DEPARTMENT REPORT

HEARING 6/5/2025

SUBJECT: H-2025-0002

Rockwell Neighborhood

E. Landscape Plan (date: 3/5/2025)

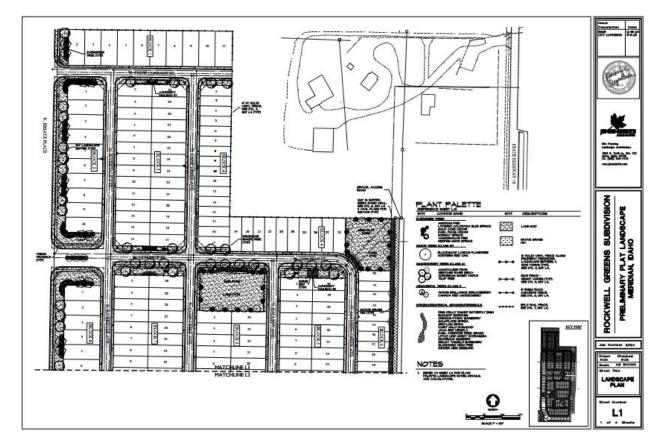
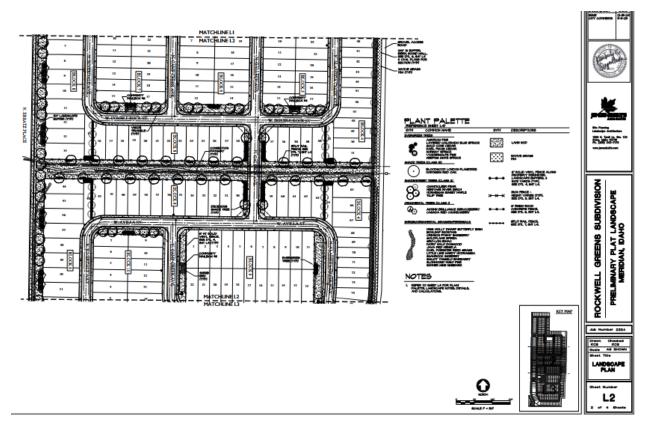
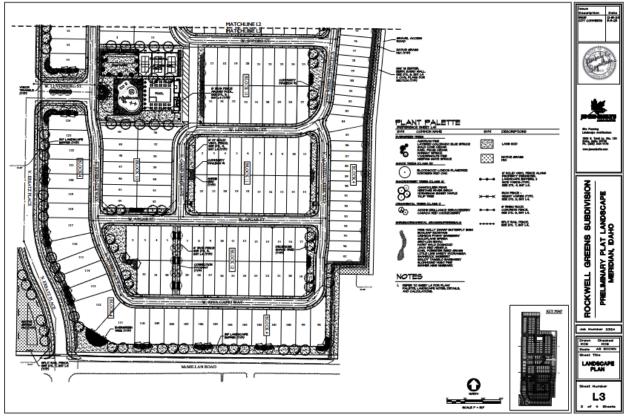
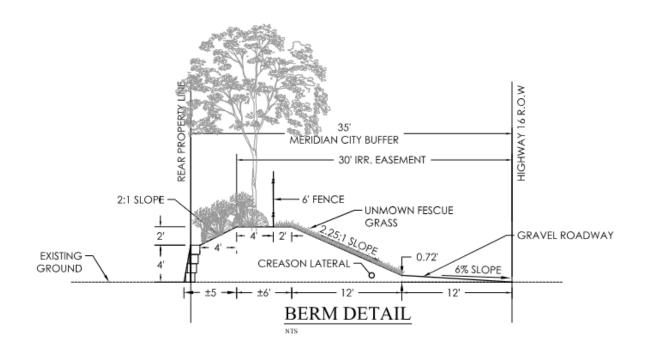
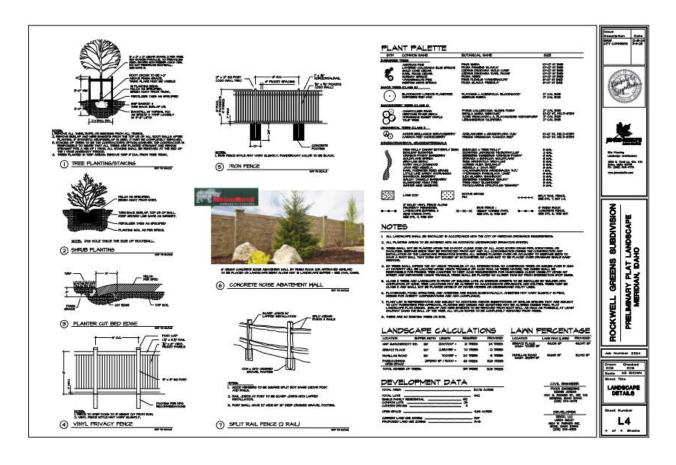
- 3. The landscape plan submitted with the final plat shall include the following revisions:
 - a. Include mitigation calculations on the plan for existing trees that are proposed to be removed in accord with the standards listed in UDC 11-3B-10C.5. The Applicant shall coordinate with the City Arborist (Kyle Yorita kyorita@meridiancity.org) to determine mitigation requirements prior to removal of existing trees from the site.

- b. Provide one (1) tree every twenty (20) feet along State Highway 16 to help mitigate for sound attenuation and air quality.
 - c. Lot 58, Block 4 shall be landscaped with 80% vegetation coverage instead of the 70% required by code to help mitigate for sound attenuation and air quality.

- d. Widen the multi-use pathways along N. Ersatz Pl to ten (10) feet as required by the pathway master plan.
 - e. Provide split rail fencing in the planters along W. McMillan Road and N. Ersatz Place to match the split rail fencing proposed in Lot 29, Block 8.

- g. Provide details on the type and location of shrubs, ornamental grasses, and perennials that will be used.
 - h. Provide a pedestrian connection to W. McMillan Road through Lot 108, Block 4, in alignment with the pedestrian connection located on Block 12.

- i. Provide a pedestrian connection in the form of micro pathway inside of a common lot with a minimum width of fifteen (15) feet through Lot 22, Block 8 and Lot 36, Block 8 in alignment with the proposed sidewalks along the west side of N. Camp Creek Avenue to provide better connectivity for the residents in the northern portion of the subdivision with the primary open space and amenities.

- j. The applicant shall enter into a license agreement with Nampa Meridian Irrigation District to landscape the first four (4) feet behind the wall abutting SH-16 as depicted in the irrigation easement or provide an additional four (4) feet of landscaping outside of the easement to allow for eight (8) feet of landscaping on the backside of the wall.

- k. Remove the northernmost entrance along N. Ersatz Place in alignment with W. Snow Currant Street to be in compliance with UDC 11-3A-3, and replace it with a micro path lot.
